THE MARYLAND-NATIONAL CAPITAL PARK AND PLANNING COMMISSION

Item #5
MCPB
10/31/02

MEMORANDUM

Site Plan
8-02003

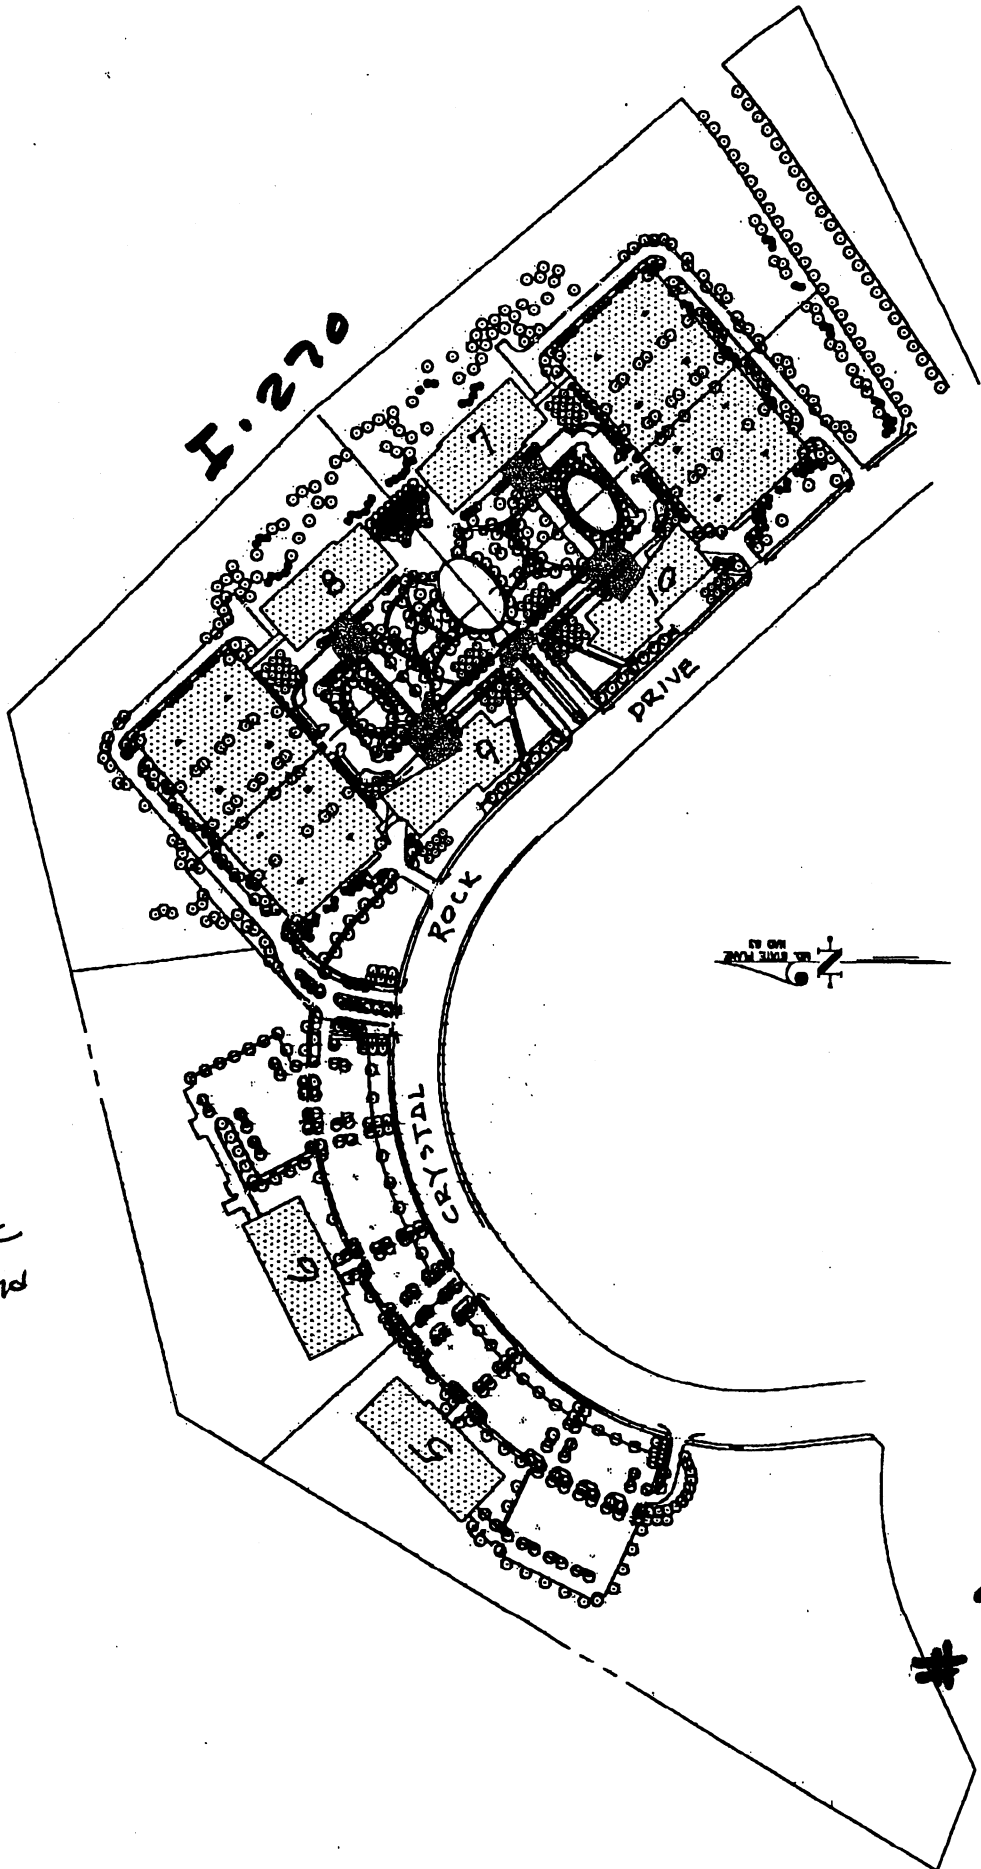
The parking decks need to include detailed pedestrian access plans that allow for internal circulation within the garage and to each building. Schematic architectural drawings with more detail are required to evaluate the success of the building connections via pedestrian bridges. This analysis will be done by the Planning Board or their designees prior to release of the building permits.

The western court contains two buildings that frame a view to the woods beyond to the north. The buildings are sited so the extreme grade from the parking lot down to the wooded area to the north is taken up between the building and the parking garage thus allowing more trees to be saved in the wooded area beyond. The surface parking lots are well connected to the building entries and the adjacent sidewalks, creating good pedestrian connections to the building.

Landscaping proposed for the building provides shade trees within all the parking areas, street trees along Dorsey Mill Road (they are provided along two sides of Crystal Rock Drive with an adjacent-site plan approval), screening for the parking lots and open space landscaping to create park like settings and preservation of existing trees. The plan lacks detailed planting for pedestrian areas at this time, the applicant plans to develop those schemes when the building architecture is finalized.

Figure 1'

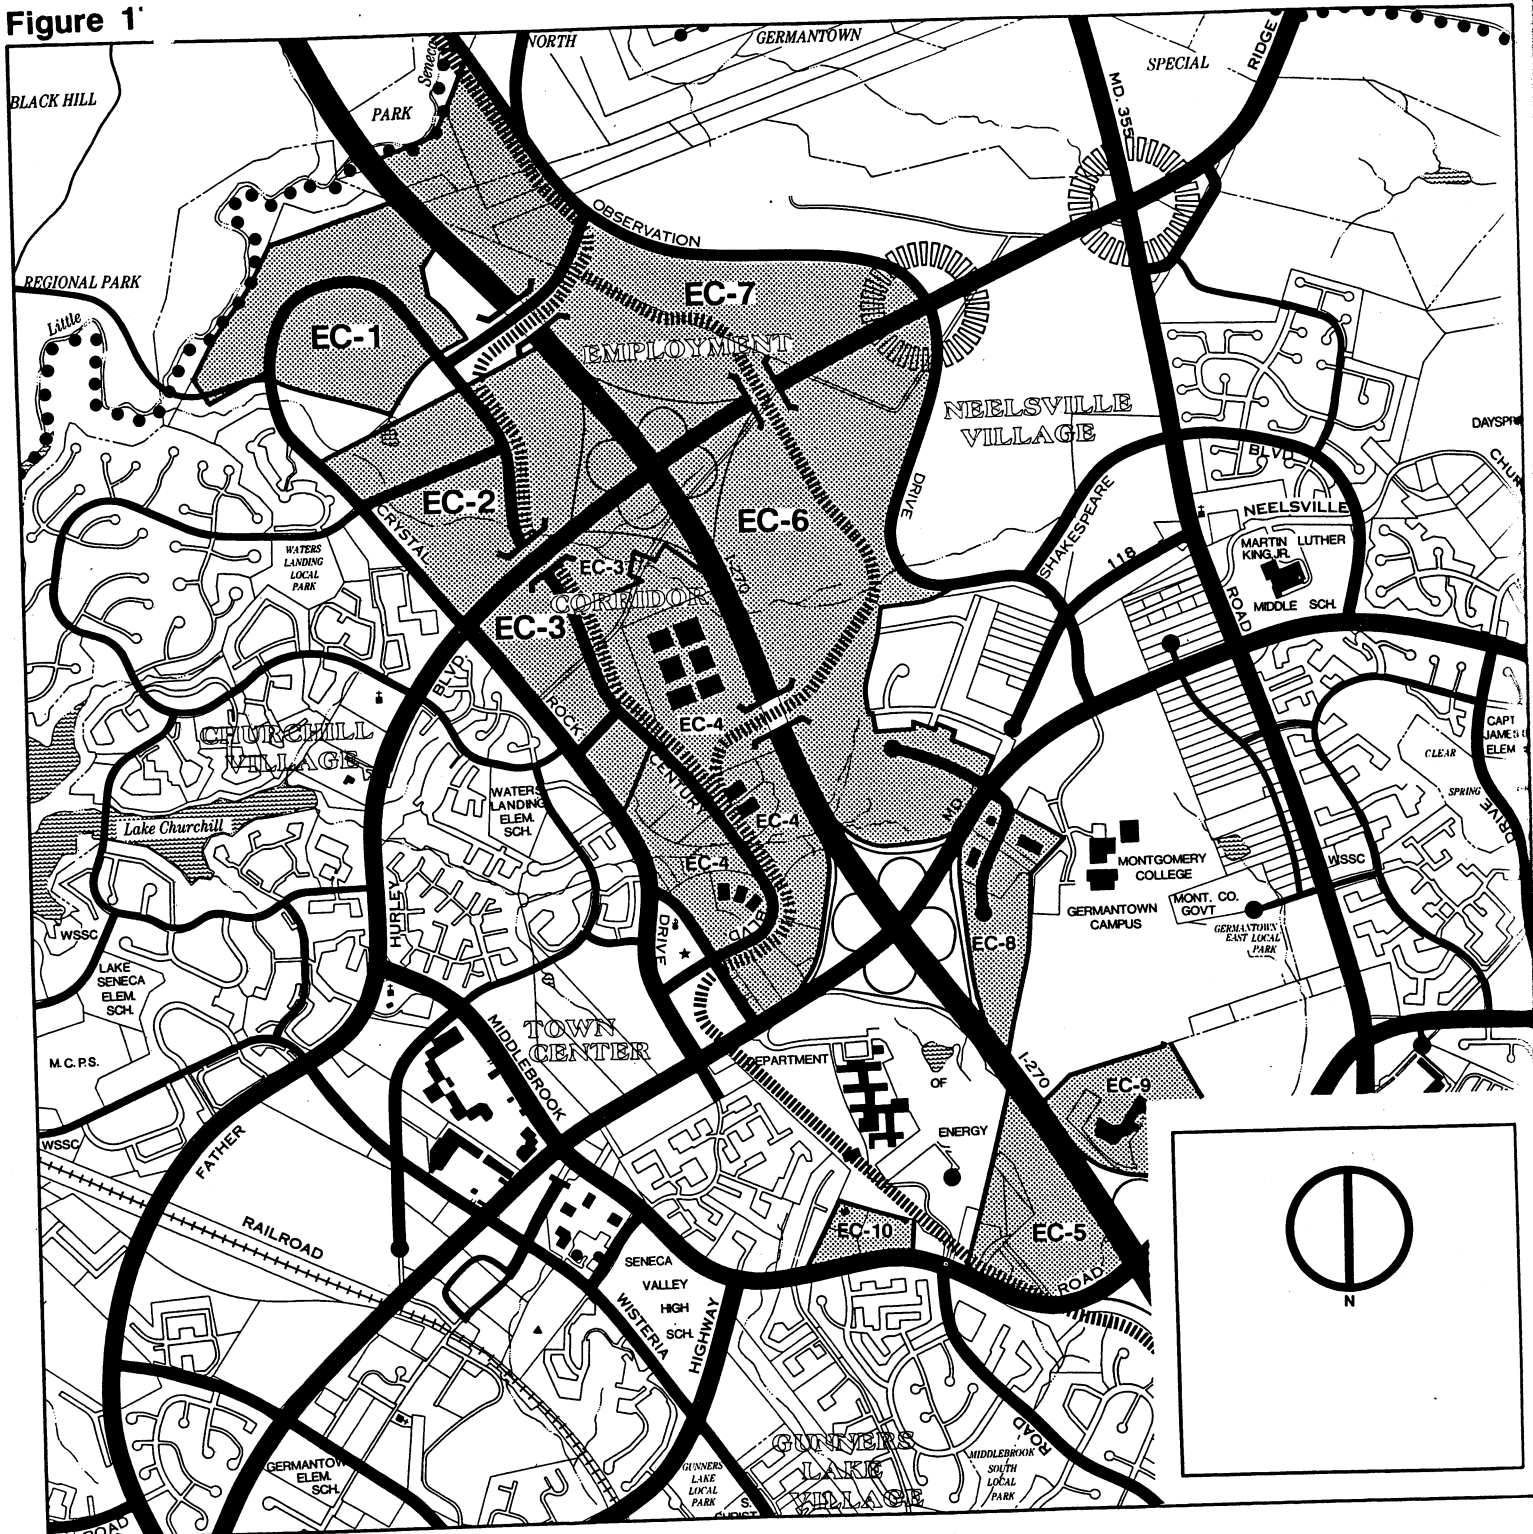
The Germantown Master Plan included a park access road to Black Hill Regional Park from Crystal Rock Drive as shown in Figure 1. The location shown on the maps was intended to be illustrative of a more specific alignment that might be coordinated with private development or the Black Hill facility master plan.

Master Plan. Option 3 would potentially impact parking and circulation for Buildings 5 and 8 of the subject property. On May 9, 2002 the Planning Board endorsed the "No Build" alternative, therefore eliminating potential impact to the subject property.
